COMMUNITY BOARD FEEDBACK PACKAGE

Business Name: GARDENIA TERRACE

Cafe Location: 826 10TH AVE, NEW YORK, NY, 10019

Application Number:20240529010004

Roadway Cafe Site Plan Form

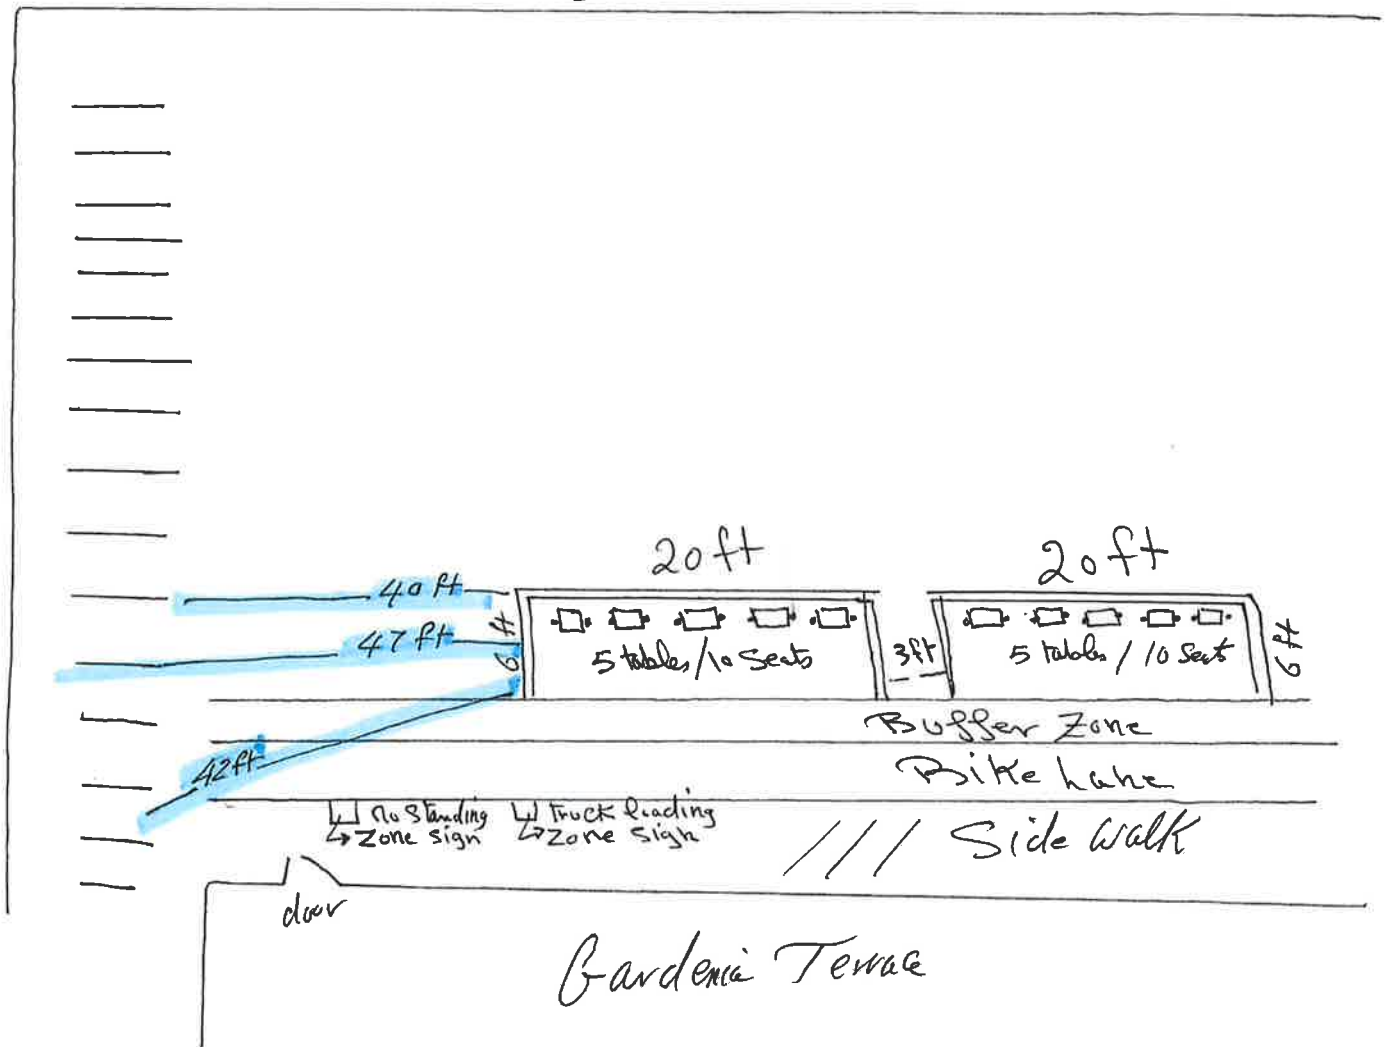
- The roadway is approximately 26.5' wide (curb to bike lane).
 - The floating parking lane on the south side of the street is 7.5' wide.
 - Applicant is proposing a 6' wide structure.
 - If implemented, the emergency travel lane remaining would be 13' wide.

FDNY City Planning issued a memo titled '*NYCDOT's Dining Out NYC Program*', dated 7.30.24, which provides recommended safety practices. The proposed Roadway Café is not in compliance as outlined:

<u>Criteria from memo: NYCDOT's Dining Out NYC Program</u>	<u>FDNY City Planning Comments</u>
1.1 The FDNY does not encourage the implementation of such variances (Roadway Cafés that propose reducing the emergency travel lane width to less than 15' (feet).	The proposed Roadway Café would reduce the emergency travel lane to 13'.

The proposed Roadway Café would present an obstruction that has potential to negatively impact firefighting operations. However, the FDNY Bureau of Operations has determined this impact to be minimal, and thus with coordination with local units the FDNY has no objection this street design implementation. The applicant is to reach out to Battalion 9, Engine 40, Ladder 35, at (bat009@fdny.nyc.gov, eng040@fdny.nyc.gov, lad035@fdny.nyc.gov) prior to occupancy of the Roadway Café and provide the opportunity for familiarization. Considerations offered by the administrative company shall be incorporated if feasible.
